Final Modification Report

CMP423: Generation- weighted Reference Node

Overview: This modification seeks to amend the reference node to generation-weighted instead of Demand-weighted

Status summary: This report has been submitted to the Authority for them to decide whether this change should happen.

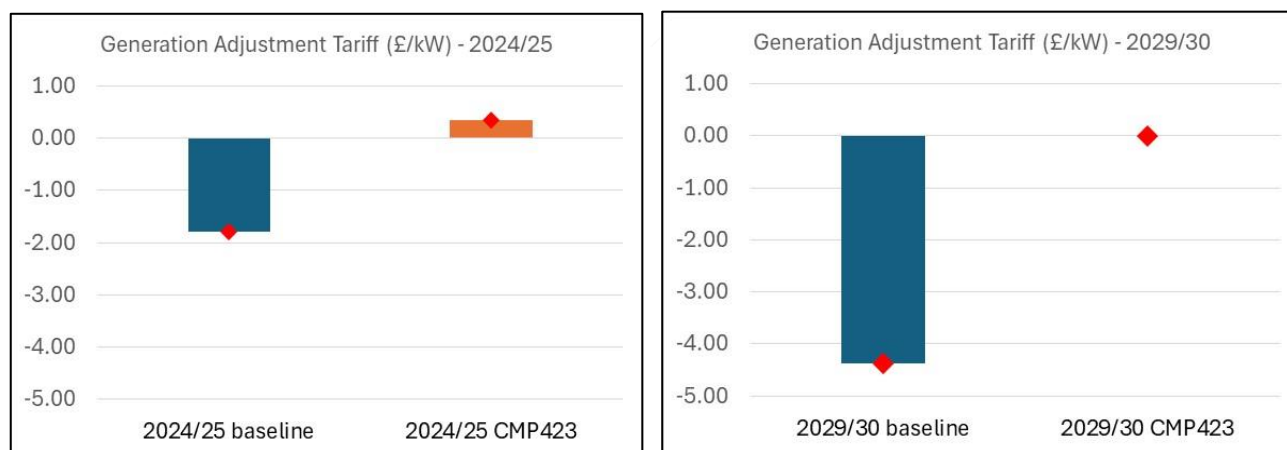
The graph below shows the Generator Adjustment Credit as a substantial negative number (credit) in the Baseline, then either positive (charge), or zero following CMP423.

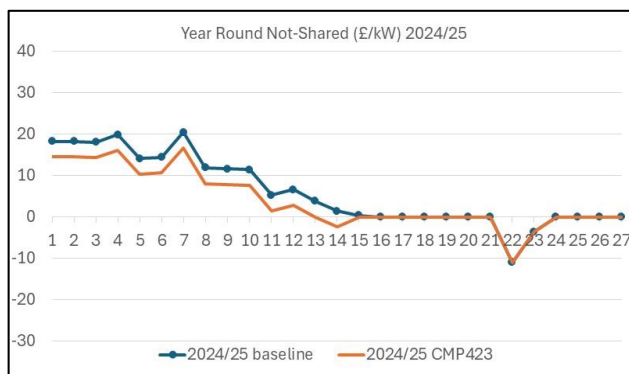
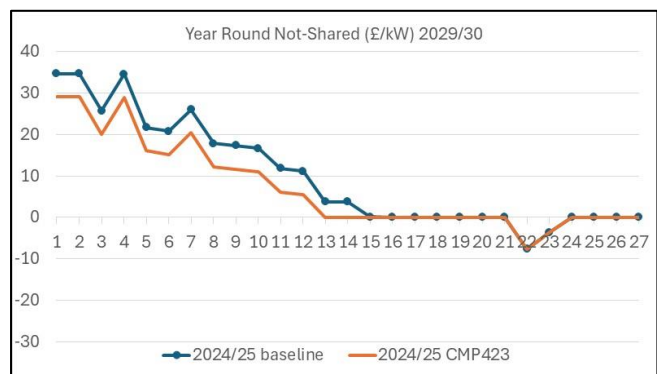
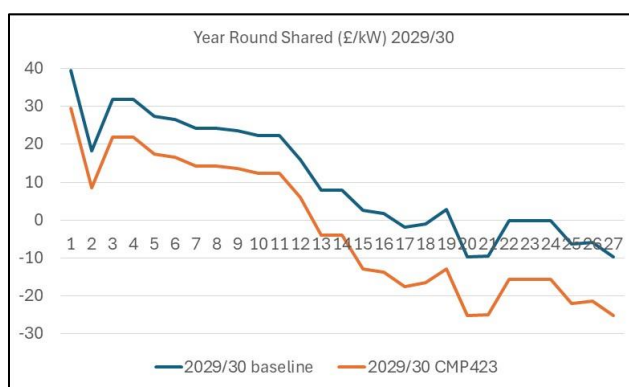
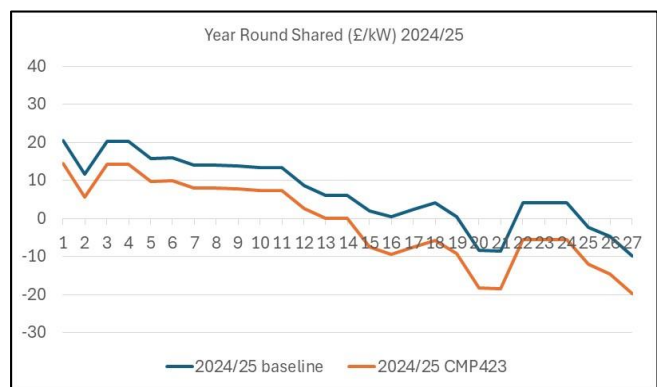
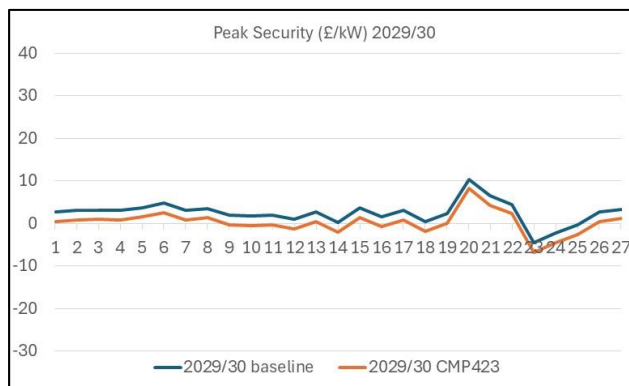
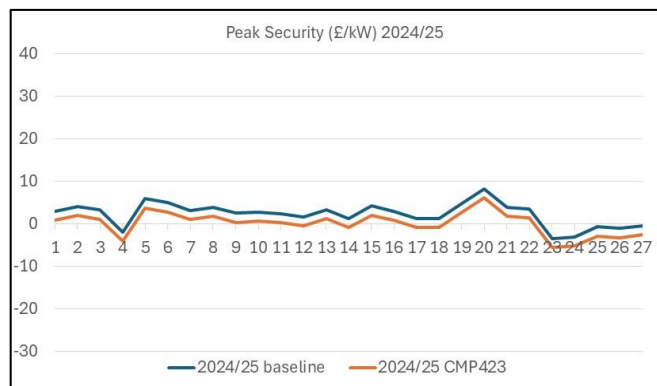
One Workgroup member queried whether Interconnectors and Storage acted as a substitute for Generators, noting that they thought they served an arbitrage function instead, as generation still needs to occur for them to work. The NESO SME agreed to investigate how scaling factors could be removed from the analysis and the possibility of running the model excluding Interconnectors and Storage. One Workgroup member queried whether excluding these Users was appropriate.

NESO presented tariff and revenue impact analysis (**Annex 04**) with and without scaling Storage and Interconnectors. Following the Workgroup discussion and consideration of NESO modelling, the Proposer decided that the Original solution would treat Storage and Interconnectors in the same way, and pro-rata scale them in the same way as other forms of generation when applying the Generation-weighted reference node.

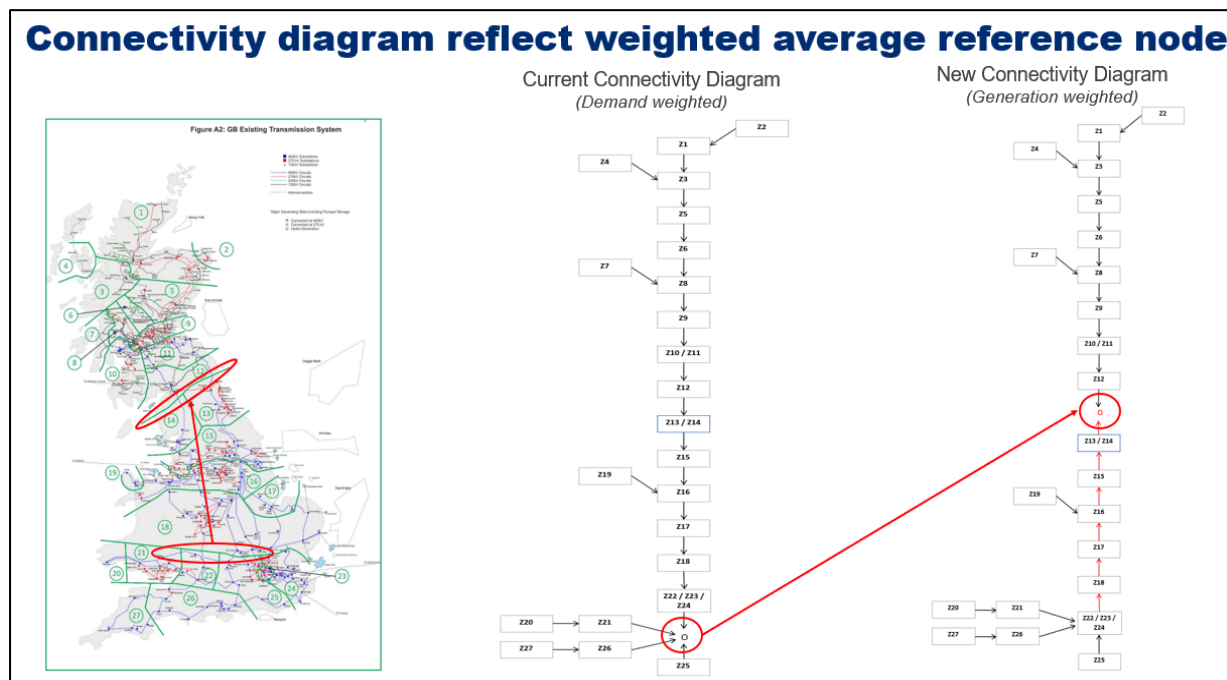
The Proposer explained that by changing to a generation-weighted reference node, the Year Round incremental MWkm weighted average zero point moves north, as shown in the graph below.

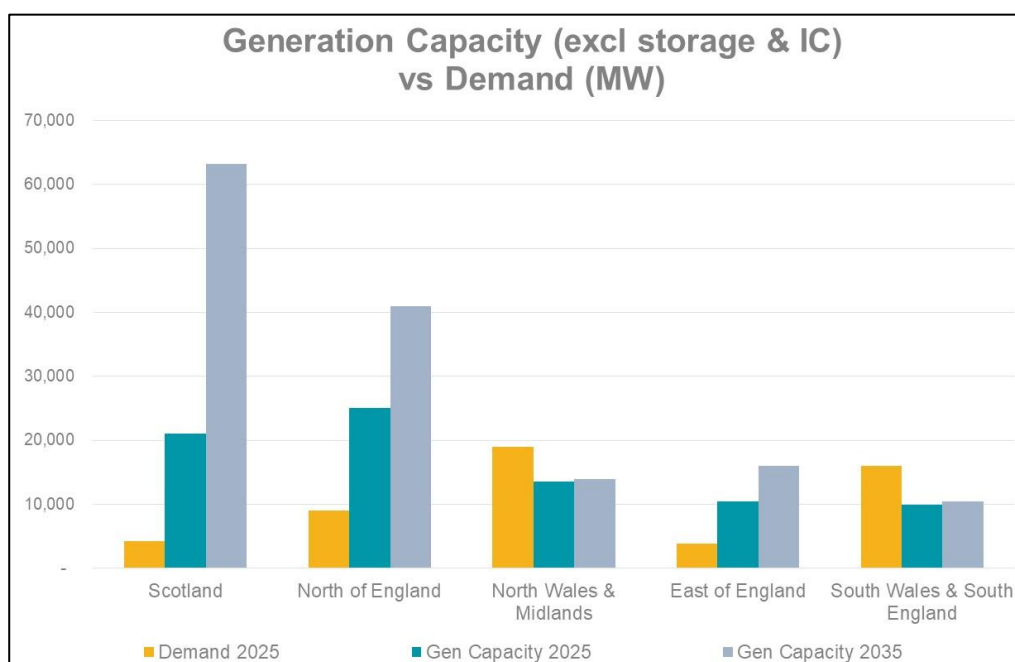
The Proposer described how that change would be reflected in the TNUoS Transport and Tariff model, as per the figures below.

The Proposer clarified that this change would be practically reflected in the Transport and Tariff model “TxNetwork” tab.

The Workgroup discussed and agreed that the analysis covers the implications for the network sharing calculation in the Transport and Tariff model.

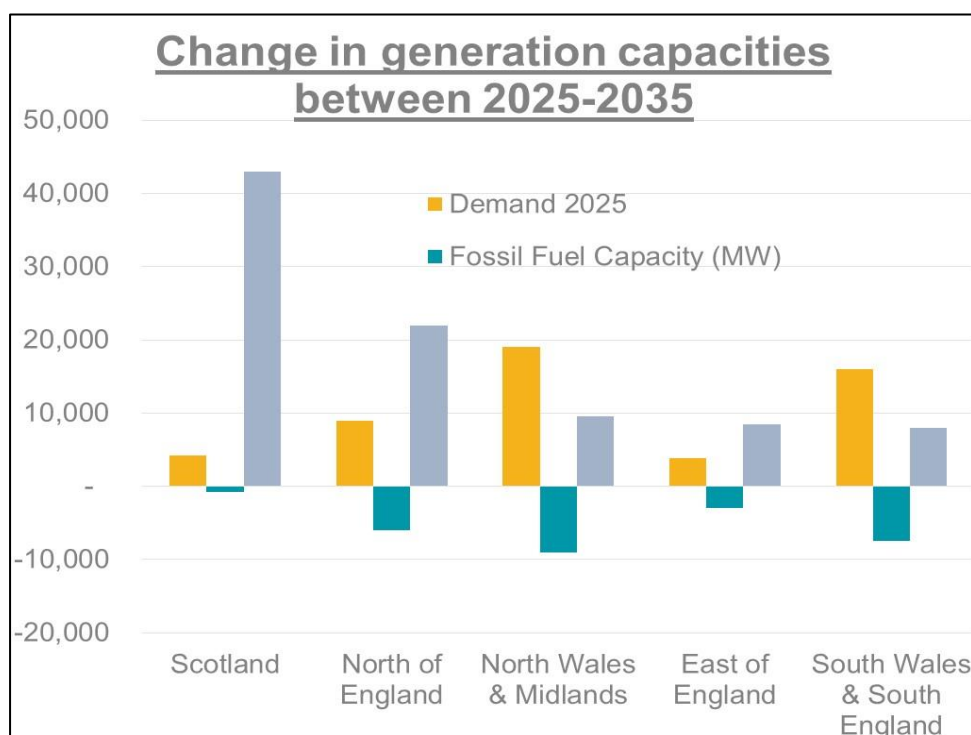
A Workgroup member requested that the Proposer look at trends in Future Energy Scenarios (FES) Scenarios in relation to this Term of Reference and asked for the graphs shown to be extended to cover the levels of Generation by zone with Peak Demand and Year Round Demand. One Workgroup member queried what the change in Generation capacity would look like out to 2040, so the Proposer agreed to extend the graphics they had presented.

The Proposer presented some analysis regarding how the location of generation and Demand may change over time, based on the NESO FES Leading The Way scenario. The Proposer explained that this showed that while the relative locations of Demand remained relatively unchanged between 2025 and 2035, there was a large change in the locational capacities of generation. The Proposer expressed that this data supported the principle of CMP423 in as far as it showed that additional generation capacity is expected to disproportionately locate in areas where there is already generation located, and by contrast, new generation is not expected to be driven by locations where Demand is located.⁹

Location of new generation is closer to existing generation than demand

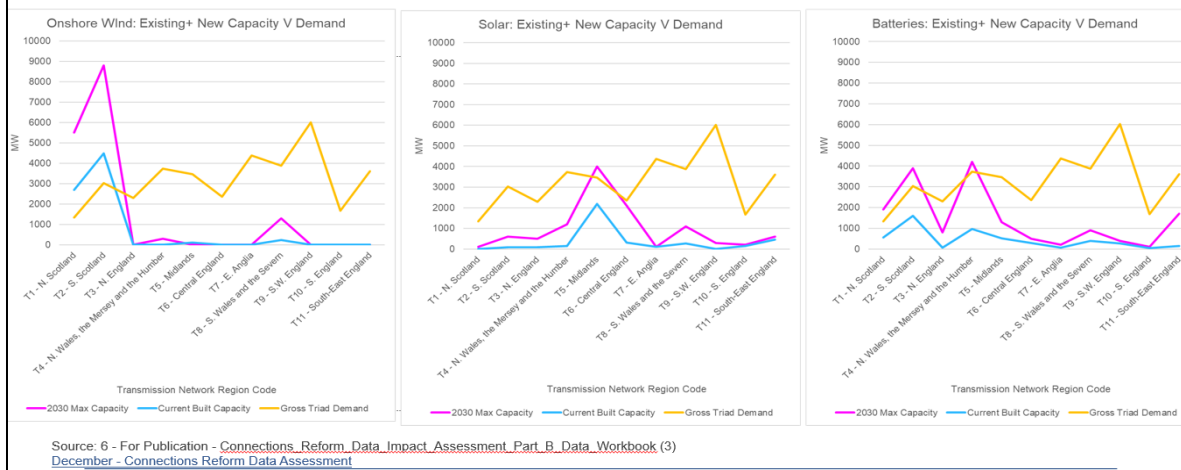
The Proposer presented further analysis on the locations of new generation and explained that this further supports the position that new generation is more likely to locate where there is existing generation, rather than locate where there is existing Demand. The presentation was summarised in the figures below.
